Inspection Report for North Sturbridge Road Solar Facility

NPDES ID No.: MAR10031G

Inspection Date: 11/15/2021

**FIGURE 1:  
SWPPP  
INSPECTION  
SKETCH  
11/15/2021**

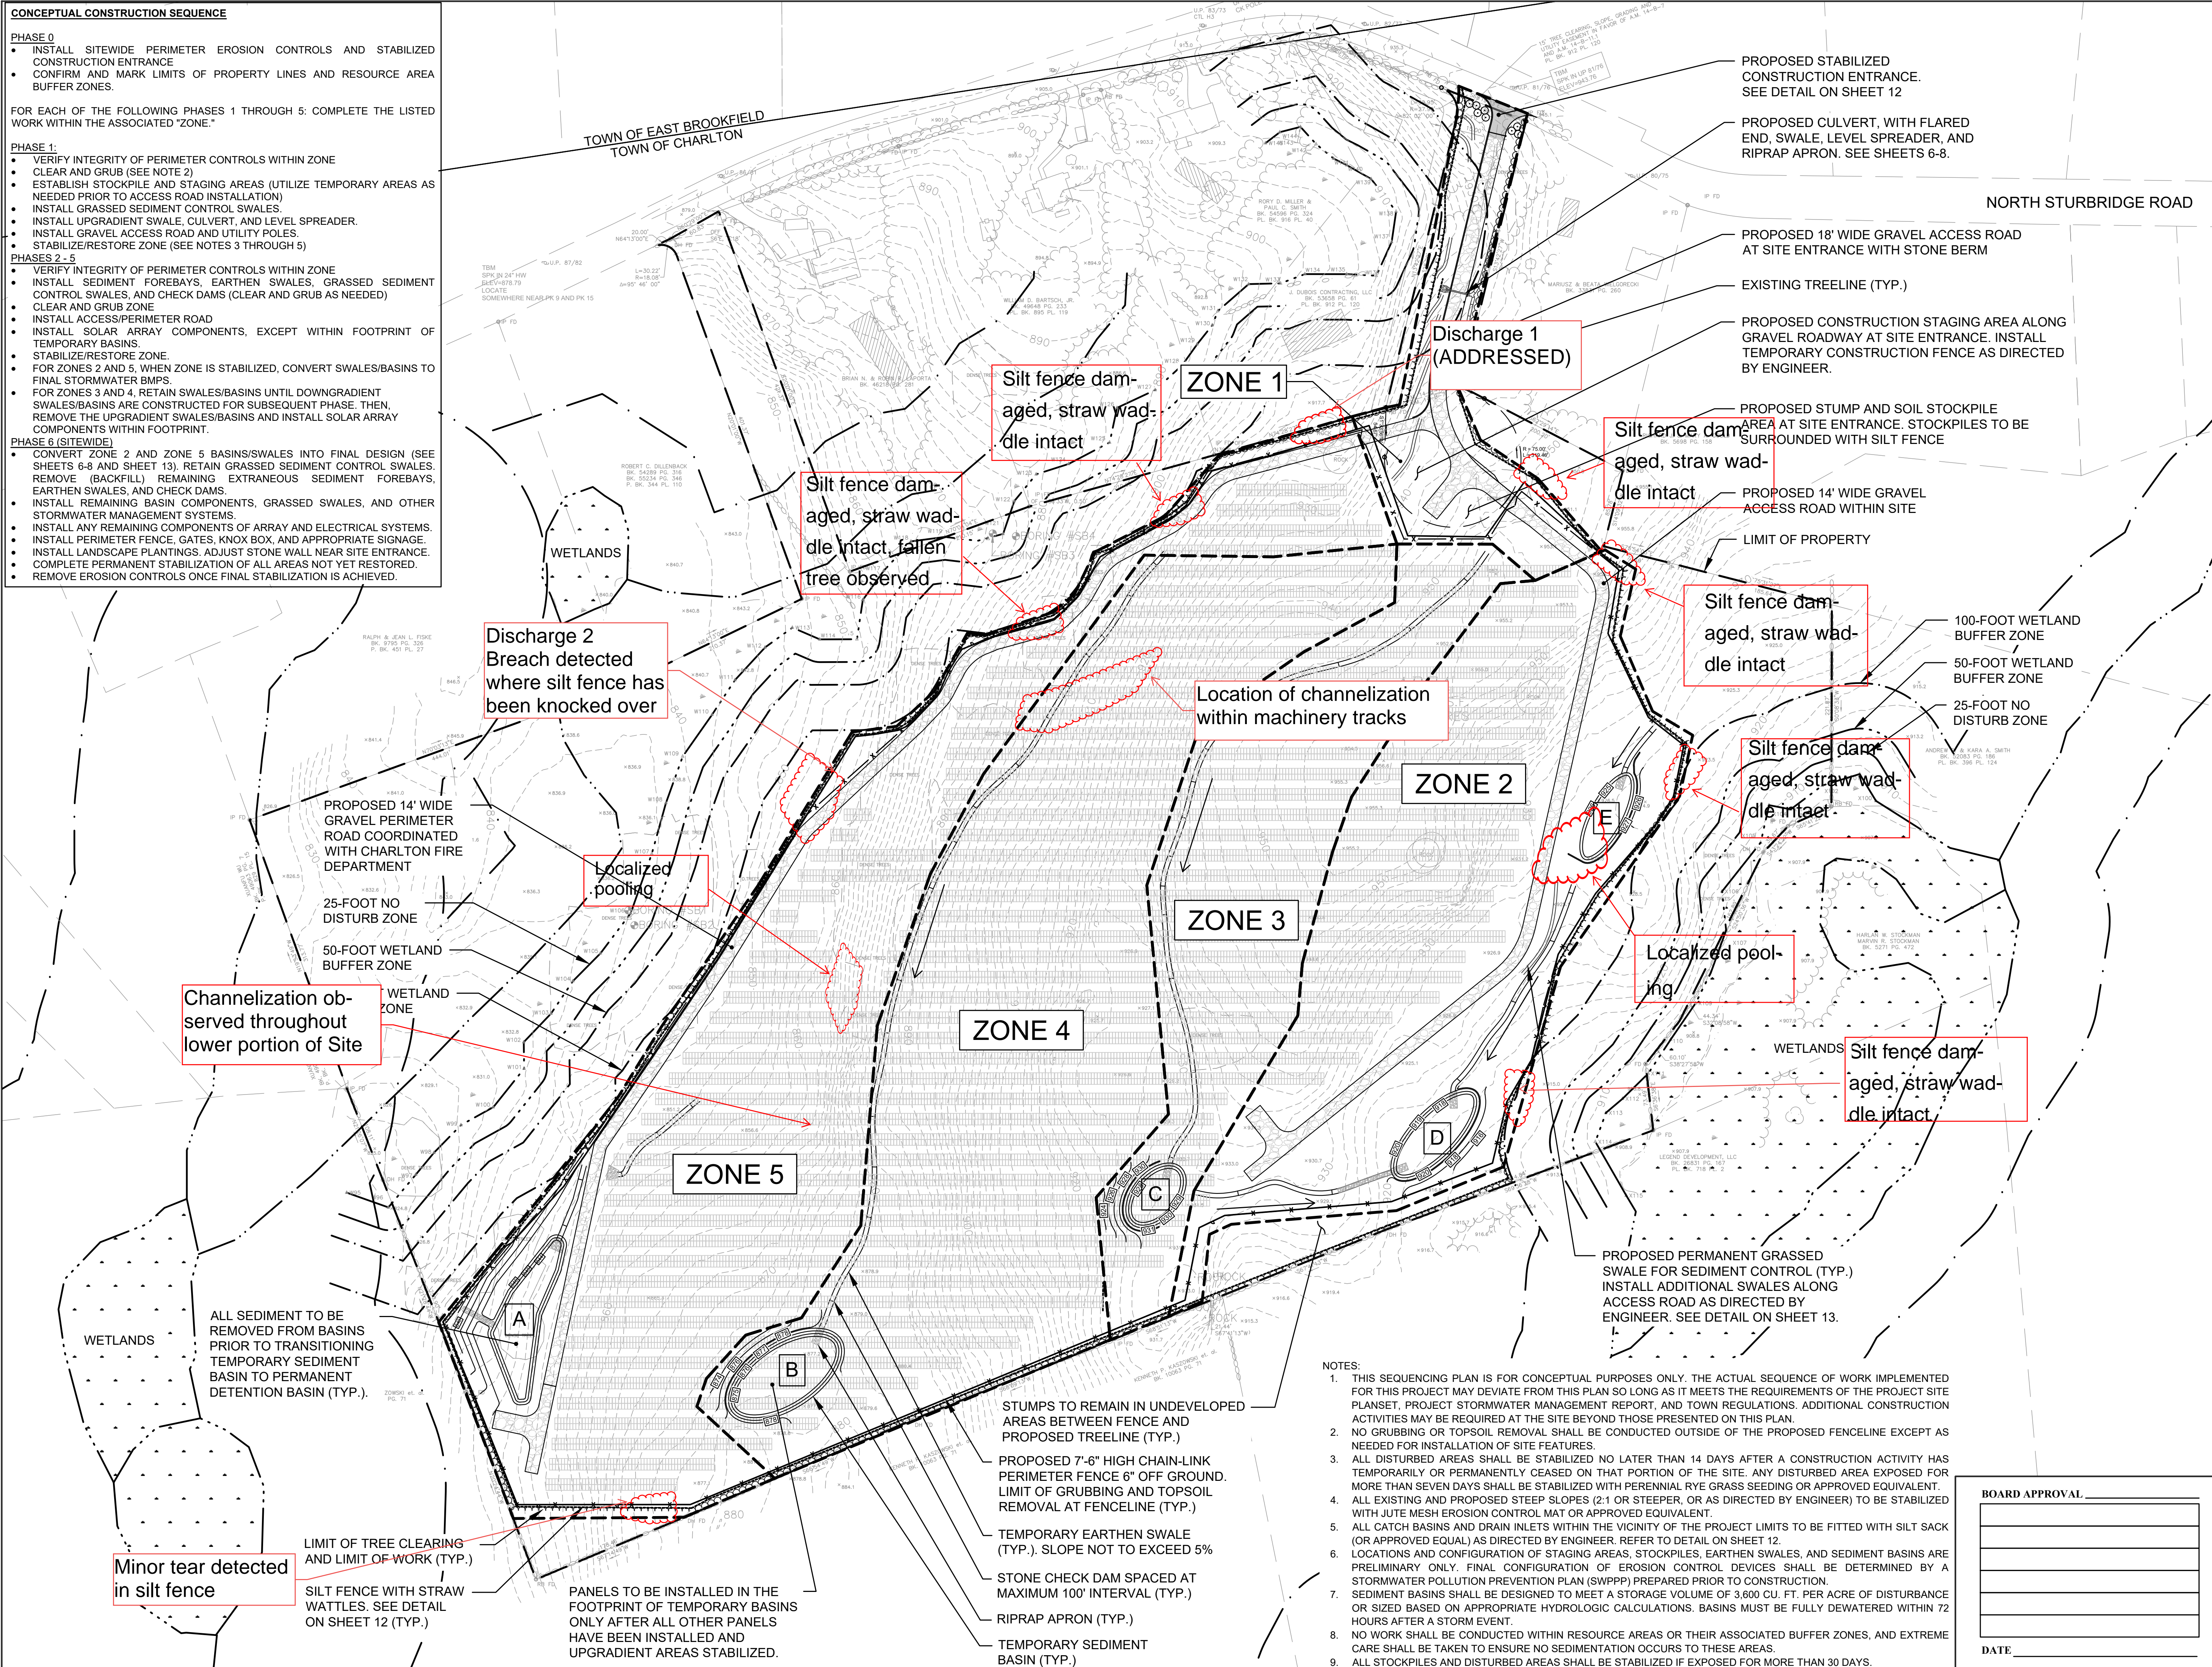
| Stabilization of Exposed Soil (CGP Part 2.2.14)              |                          |  |  |
|--|--------------------------|--|--|
| 2. Informal access road along northern portion of the Site   | Straw mulch or hydroseed | <input type="checkbox"/> Yes [Enter date] <input checked="" type="checkbox"/> No | Erosion channels are beginning to form within upgradient portions of the informal access road (Figure 1). The contractor indicated that stabilization by smoothing out soils and seeding or spreading mulch would occur on 7/30/2021. Stabilization of this area has not been initiated. After inspection of the area on 8/24/2021, it was determined that |

Localized pooling

Silt fence damaged, straw wad-dle intact

Minor tear detected in silt fence

Channelization observed throughout lower portion of Site

Location of channelization within machinery tracks

Silt fence damaged, straw wad-dle intact, fallen tree observed

Discharge 2 Breach detected where silt fence has been knocked over

Discharge 1 (ADDRESSED)
